From: Jonny Pickup <jonny.pickup@tcps.org.uk>
Sent: 19 February 2025 12:27:29 UTC+00:00
To: "Anna Tidey" <anna.tidey@midsussex.gov.uk>
Subject: RE: Representation received for DM/24/2505 - 50 Hurst Road, Hassocks

I refer to the Arboricultural Implications Assessment for Proposed Tennis Court prepared by Broad Oak Tree Consultants Ltd - 16/12/2024.

Appendix 3 indicates the scope of works and ground protection area for the root plates of my row of 7 hornbeam and privet trees that run along my boundary adjacent to the proposed tennis court. (Indicated in red on attached)

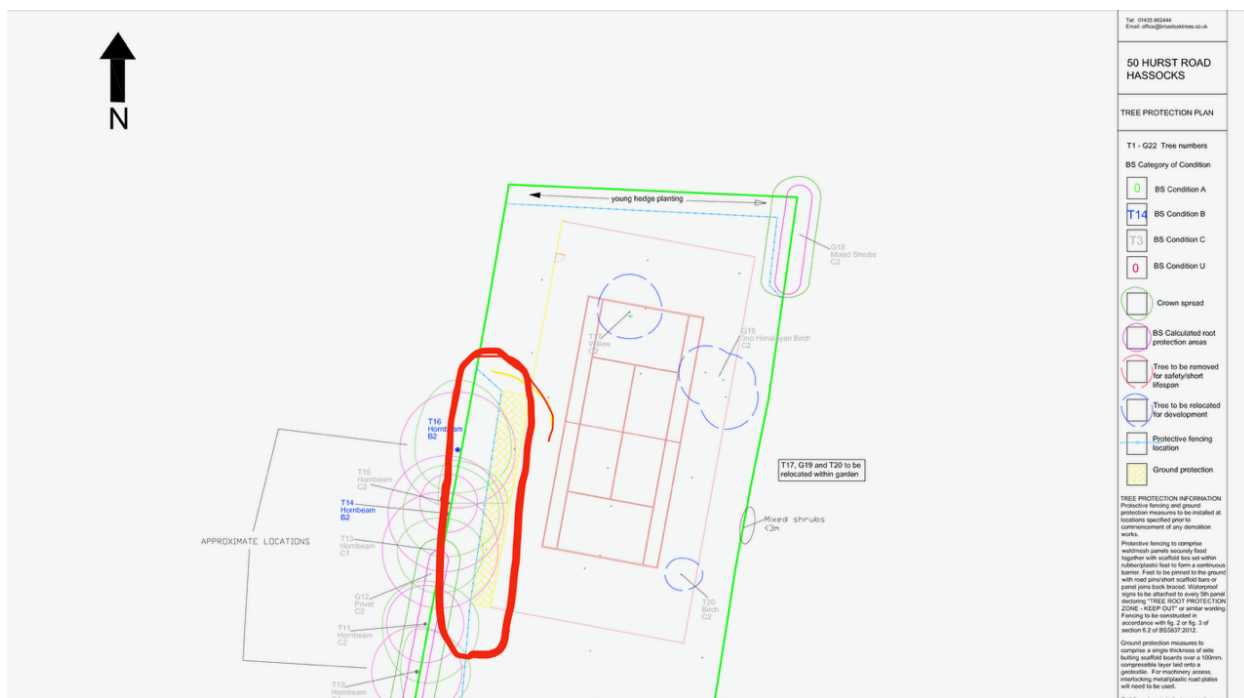
- details of the proposed footings for the load bearing retaining walls,
- any encroachment that these may cause to the tree root protection areas/plates,
- and the width/position of the required mechanical access routes for the construction of these walls?

The proposed application suggests the scope of works includes approximately 3 metres of ground excavation works at the southern end of the proposed tennis court. Significant load bearing retaining walls will be needed to ensure elimination of ground movement onto the court. These load bearing retaining walls will likely require significant footings with reed bar / block construction or similar and ordinarily 215mm in thickness.

As can be seen on Appendix 3 the root plates of my trees actually encroach onto where the retaining walls will need to be situated. The plan on Appendix 3 of the report does not indicate the location of these significant retaining walls and encroachment to the root plates.

To construct and install such load bearing retaining 2.75m walls will require probably at least 1.5 metre further access into where the tree root plates are shown on Appendix 3. Imposing a significant impact to the root plates of my 7 trees bordering my boundary, severely damaging the root plates and potentially killing the trees.

This is not a planning matter. However, the architect expects that this would be a standard 600mm wide trench concrete footing.

As shown in the Arboricultural Impact Assessment, the trees adjacent to the tennis court would all be relocated to elsewhere in the garden. As such, no trees would be impacted by the retaining wall.

Again, this is not a planning matter relevant for a householder application. However, the architect would expect that this would be a 1.5m wide route accessed from the east side of the dwelling.
